RAI 02.04.12-48**QUESTION:**

RAI 02.04.12-49**QUESTION:**

RAI 02.04.12-50**QUESTION:**

Figure 2-1. Representation of Clay Cap, Structures, and Retaining Walls in Post-Construction Model, Run 301PC.

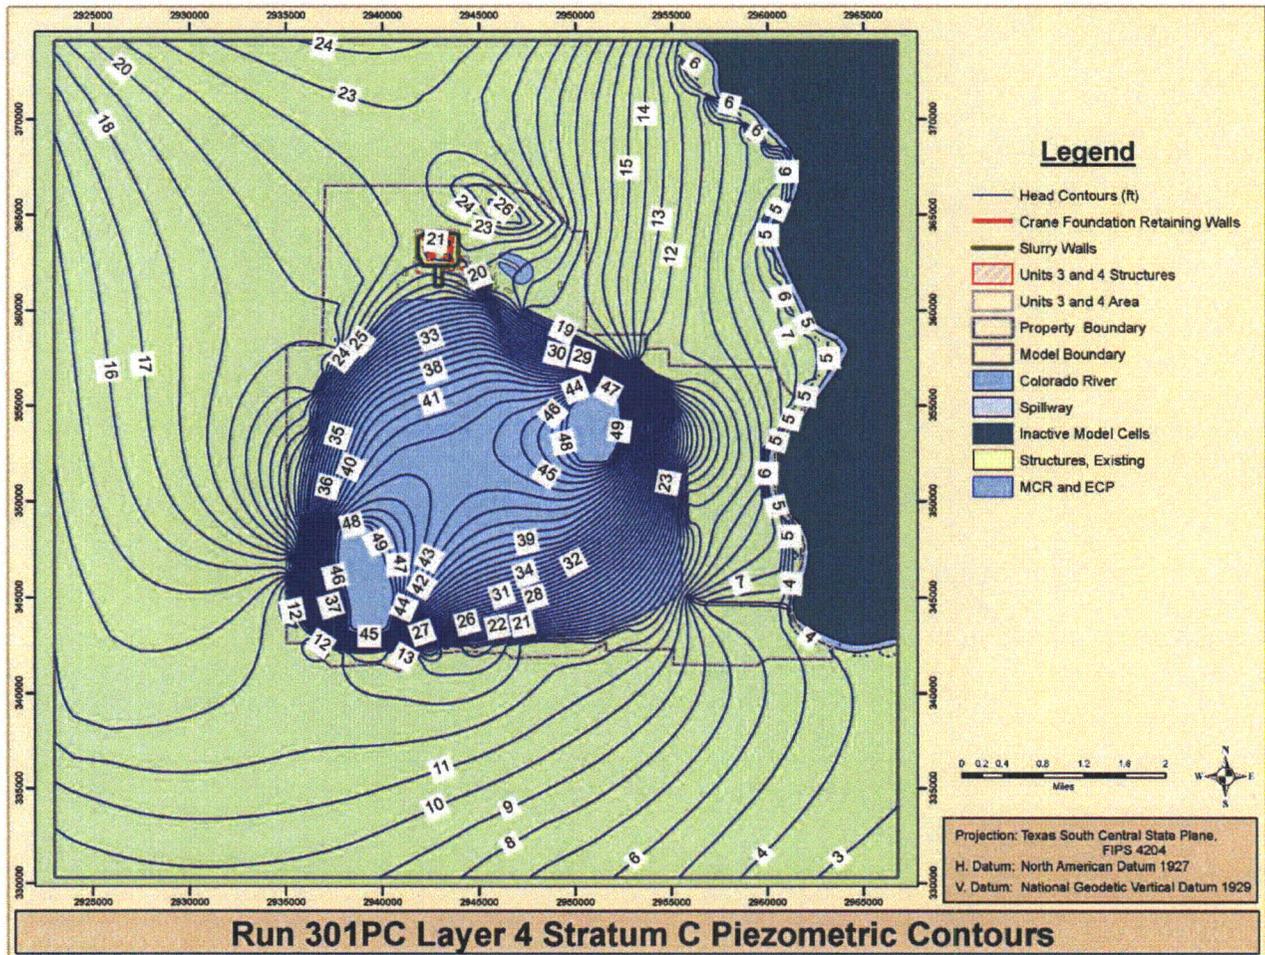
To meet the requirements of 52.79(a) and assist staff in its analysis, additional information concerning the groundwater modeling is required. Describe the sensitivity cases used to evaluate post-construction infiltration rates within the powerblock of proposed STP Units 3&4, and the excavation backfill hydraulic properties, (e.g., saturated hydraulic conductivity). In addition, describe the potential influence of structures that will remain in the subsurface. For example, in addition to the slurry wall which is simulated and described, what is the potential influence of the two Crane Foundation Retaining Walls which are described as permanent structures (890 ft long, 80 ft deep, and 3 ft wide)? Also, describe the influence of the existing relief well system on the water table within the powerblock of proposed STP Units 3&4. For example, what would occur if the system or a portion of the system failed? Alternatively, describe the conservative or bounding assumptions made in the evaluation of the maximum water table within the powerblock and the plausible pathways from the proposed STP Units 3&4 to points of possible human exposure.

Figure 2-1 shows the STP Units 3 & 4 plan-view layout of structures, retaining walls, and the clay cap material in model layer 1 of the post-construction model (Run 301PC). Table 2-1 provides the water balance for the post-construction run (Run 301PC) in comparison to the pre-construction model run (Run 301). This table shows increased discharge to groundwater from the MCR as expected with the relative MCR stage increase (i.e., pre-construction model Run 301 uses an MCR stage of 42 ft MSL whereas post-construction model Run 301PC uses the MCR spillway stage of 49.5 ft MSL).

Results of Run 301PC indicate that groundwater levels at STP Units 3 & 4 remained more than 10 feet below the post-construction plant grade elevation 34 ft MSL (Figure 2-8) and that groundwater flow originating within the slurry walls migrate to the east and southeast (Figures 2-11 to 2-13). The differences between the pre- and post-construction simulated groundwater heads are presented in Figure 2-14. The simulated groundwater levels in the post-construction model in the Upper Shallow Aquifer (Stratum C) are up to three feet lower within the power block of Units 3 & 4 and no more than one foot lower outside of the power block slurry wall compared to pre-construction simulated groundwater levels. This creates a depression in the potentiometric surface beneath Units 3 & 4 and is similar to Run 201 as explained in the response to RAI 02.04.12-42.

Figure 2-11. Pathlines from Particles Released Adjacent to STP Units 3 & 4 Radwaste Buildings in Stratum C, Post-Construction Model, Run 301PC.

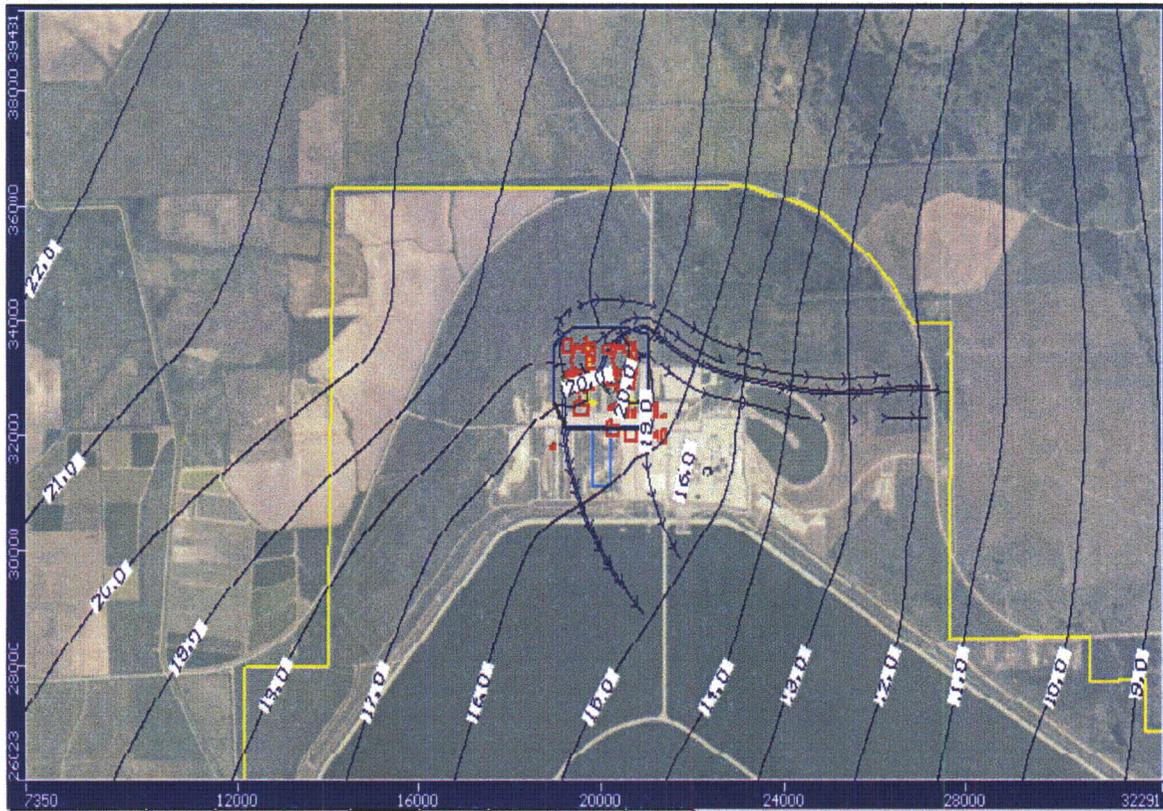
To meet the requirements of 52.79(a) and assist staff in its analysis, additional information concerning the groundwater modeling is required. The NRC notes that based on review of FSAR, Rev 3, Sections 2.4S.12 and 2.4S.13, revisions submitted to Section 2.4S.12 and 2.4S.13 on November 23, 2009 (U7-C-STP-NRC-090205), and the groundwater model results (Figures 91 and 100), the applicant may not have considered results of post-construction groundwater simulations on the southwest pathway analysis. The pathways analyzed in FSAR, Rev 3, Section 2.4S.12 and 2.4S.13 (with revisions of 11/23/2009) may not adequately consider a southwest pathway in the Lower Shallow Aquifer. The current groundwater model results indicate a 3 to 3.5 ft increase in piezometric surface at the filled excavation in the Lower Shallow Aquifer. Provide a discussion of this key simulation result with regard to the elimination of a plausible southwest directed groundwater pathway in the Lower Shallow Aquifer.

Figures 2-11 to 2-13 display the particles released in Stratum C (model layer 4), Stratum E (model layer 7), and Stratum H (model layer 10) within the Unit 3 & 4 power block, adjacent to the radwaste buildings, the source of a postulated accidental release. The particles ultimately migrate to the east and southeast similar to the particle tracks documented by Run 201 (Reference 1).

The shortest travel time to the site boundary from a radwaste building (STP Unit 3) is about 104 years. The particles released in Stratum E (model layer 7), move eastward to the site boundary. Particles that start in model layer 4 (Stratum C) move downward through the fill material to Strata E before continuing eastward or southeastward to the site boundary. The shortest travel times for the particles released in Stratum C are similar to those released in Stratum E since movement downward through the fill material is short relative to the movement through Stratum E from STP Units 3 & 4 to the eastern site boundary.
